CITY OF CONCORD

REPORT TO THE MAYOR AND CITY COUNCIL

FROM: Transportation Policy Advisory Committee

SUBJECT: Report from the Transportation Policy Advisory Committee regarding NHDOT's I-93 Bow-Concord Interstate Widening Project.

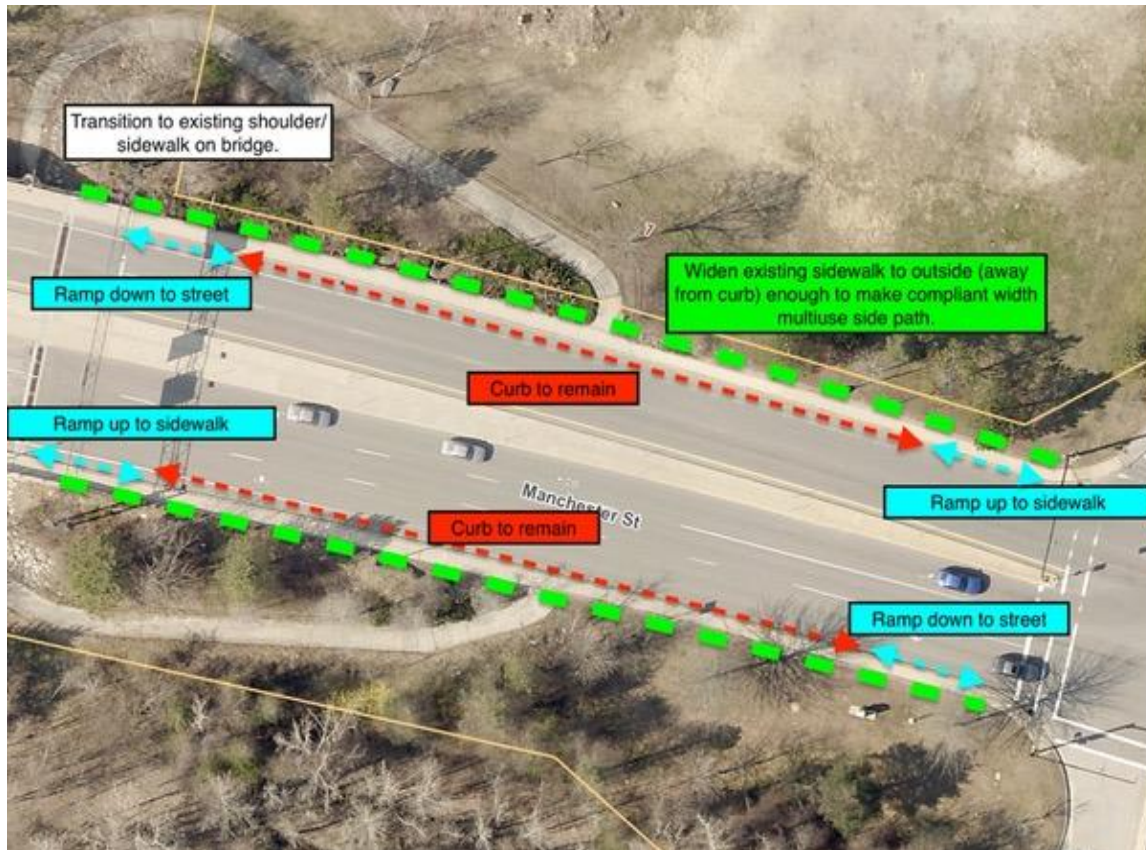
Subject to review of final designs and maintenance details, the NHDOT's proposed conceptual improvements to Exit 12 are acceptable to the Committee. The Committee recommends requesting that the NHDOT use industry standard design principles to incorporate safe access for bicyclists and pedestrians through the proposed roundabouts at this location.

The Committee also recommends that the City request that the NHDOT to consider the impacts of the highway noise to the abutting neighborhoods in the area of Exit 12.
